**Calcutta Farms Ltd**

**Industrial Zone Plan Change**

**Integrated Transport Assessment**

July 2022

**Figure 15: Typical Cross-Section – Local Road**

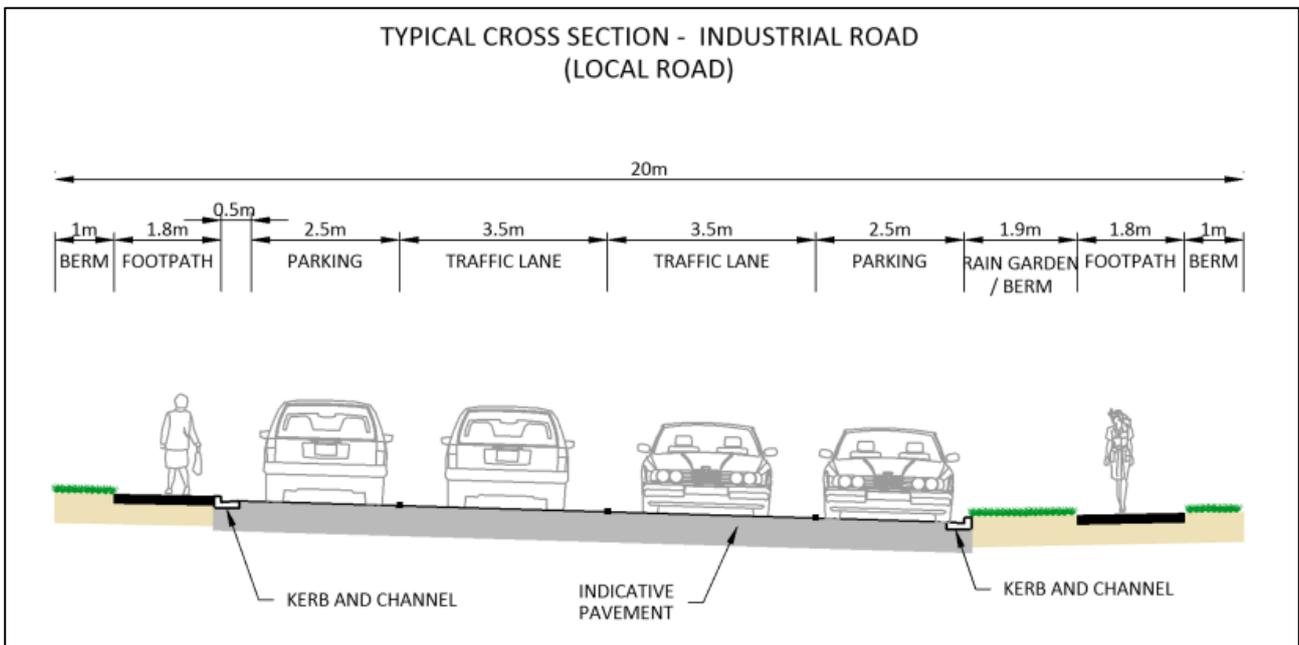
Review the proposed local road cross-section to remove the flush median and provided dedicated parking lanes on both sides of the road.	The purpose of a flush median on a local road is unclear. Cross-section should maximise potential for future on-street parking.	The ITA has been updated to reflect the revised cross section. Refer to Figure 15.	<b>Satisfied</b> ITA has been updated which indicates that the local road cross section no longer includes a flush median and parking is provided on both sides of the road.	No further action required
Confirm whether the proposed overland flow paths will provide facilities to support walking and cycling.	Access to and connectivity within the area would be enhanced if these overland flow paths also include facilities to support walking and cycling.	There is also an opportunity to provide walking and cycling facilities along the overland flow paths, however, the exact location and design for them will be confirmed at the time of subdivision.	<b>Not satisfied</b> The response identifies that there is an opportunity. However, the exact location of any walking and cycling paths within the overland flow paths will be provided at the time of subdivision.	It would be prudent to identify walking and cycling connections at plan change stage to better understand how pedestrian and cycling connectivity will be provided. This could potentially be addressed through the plan provisions, e.g. assessment criteria or rules requiring public walking access along these connections

**Response:** The ITA has been updated to reflect the revised cross section. Refer to Figure 15.

Figure 22: Existing SH24 / Tower Road / Burwood Road Roundabout Layout

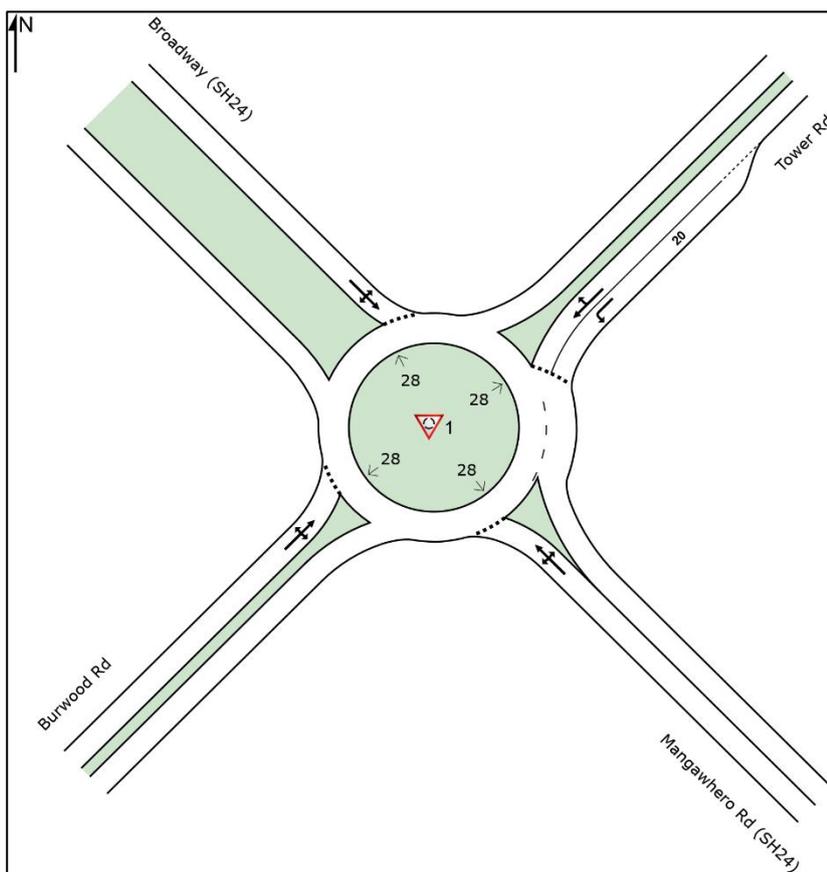
(k) *Based on the existing configuration of the Tower Road approach to the roundabout illustrated in Figure 21, we consider that the approach would operate as a continuous lane and a short left turn lane rather than as a single lane as illustrated.*

Figure 23: Minimum Intersection Upgrade at SH24 / Tower Road / Burwood Road Roundabout

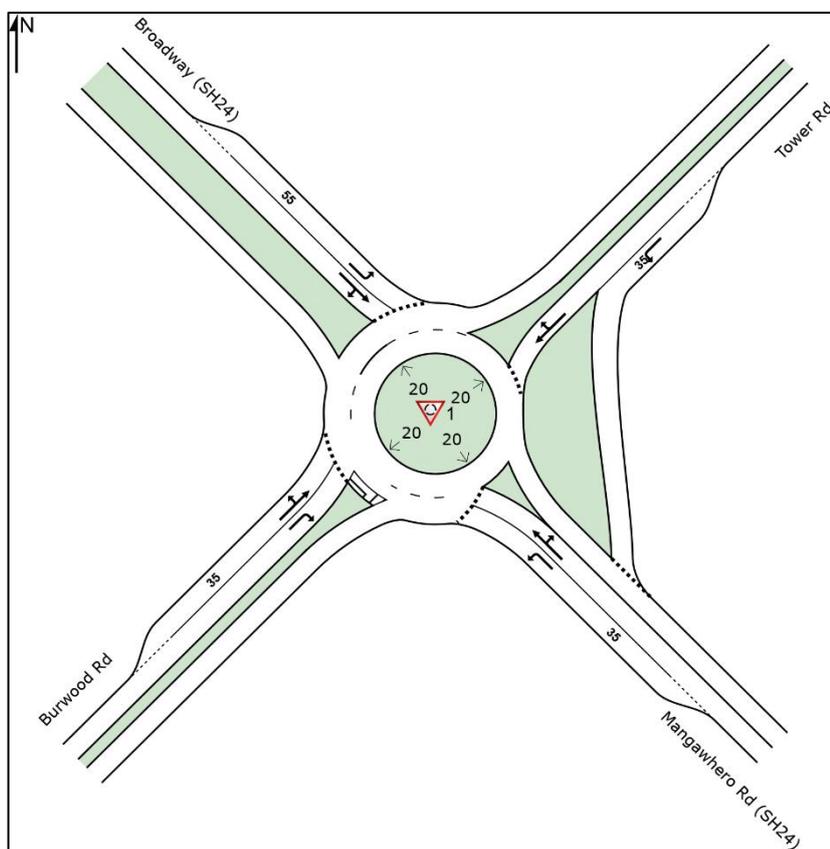
- (l) *Figure 22 illustrates a redesigned roundabout with a smaller central island and more approach lanes. Comparing the existing roundabout with boundary locations, it appears that the boundaries to the north and south of the roundabout (between SH24 and Tower Road, and SH24 and Burwood Road respectively) are very close to the roundabout. Therefore, the question arises as to whether the configuration illustrated in Figure 22 can be constructed. It is not clear how pedestrians and cyclists would be accommodated at the reconfigured roundabout illustrated in Figure 22.*

**Response:** Drawing 146930-02-0234 illustrates the feasibility of upgrading the SH24 / Tower Road / Burwood Road roundabout without encroaching into neighbouring properties. The proposed upgrade design was to mitigate the capacity issue of the roundabout. As for pedestrians and cyclists, typical kerb cut-down crossing points at the roundabout splitter islands will be provided which is an improvement to the existing arrangement where kerb cut-down crossing is only provided at the Burwood Road approach. A raised safety platform is also provided along the Mangawhero Road (SH24) approach such that vehicle speeds would be sufficiently low to achieve a safe system crossing point. There is an opportunity to provide safer crossing facilities such as raised safety platforms on other approaches. However, the cost of these improvements is to be shared equally within all affected parties (i.e. Waka Kotahi, MPDC and Calcutta Farms).

Figure 25: New Roundabout Access

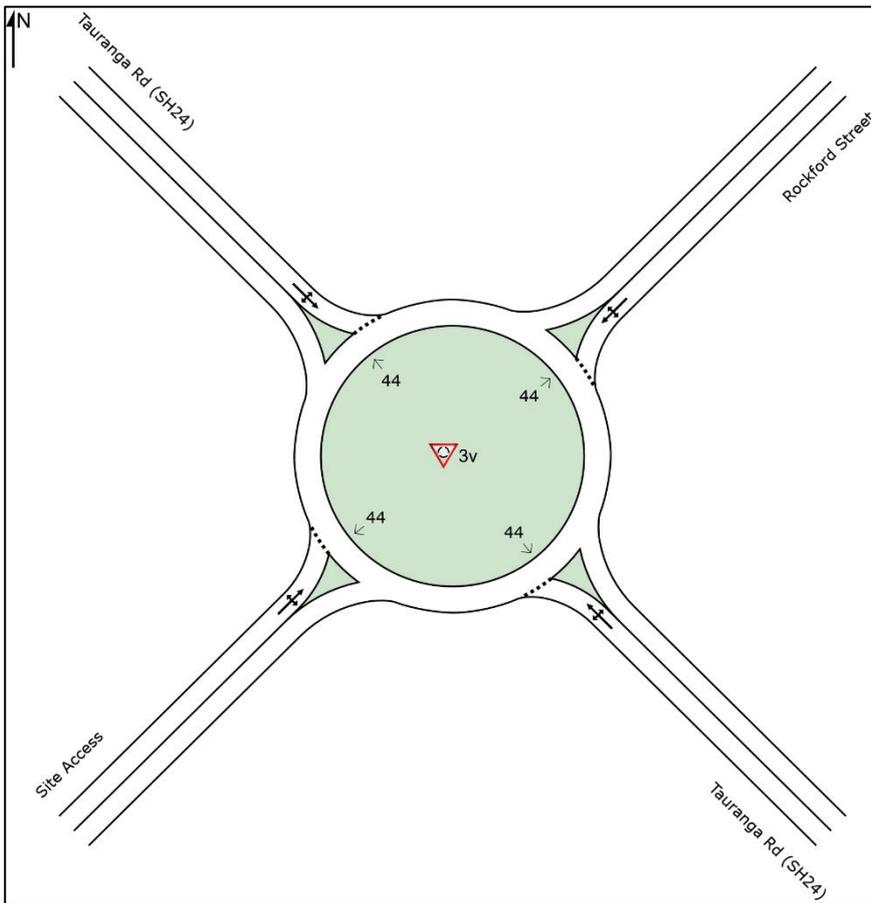
- (m) *The site access roundabout is illustrated as having a 44 m diameter central island (Figure 25) and, as noted previously, a proposed speed limit of 50 km/h. The Tower Road roundabout, which is within a 50 km/h speed limit area, is illustrated (Figure 21) as having an existing central island diameter of 28 m, which the Applicant proposes to reduce to 20 m (Figure 22). The ITA does not appear to explain why it is acceptable for one roundabout to have a 44 m diameter, but another where traffic volumes are higher to have a 20 m diameter. It would be useful for the ITA to include discussion regarding these differences.*
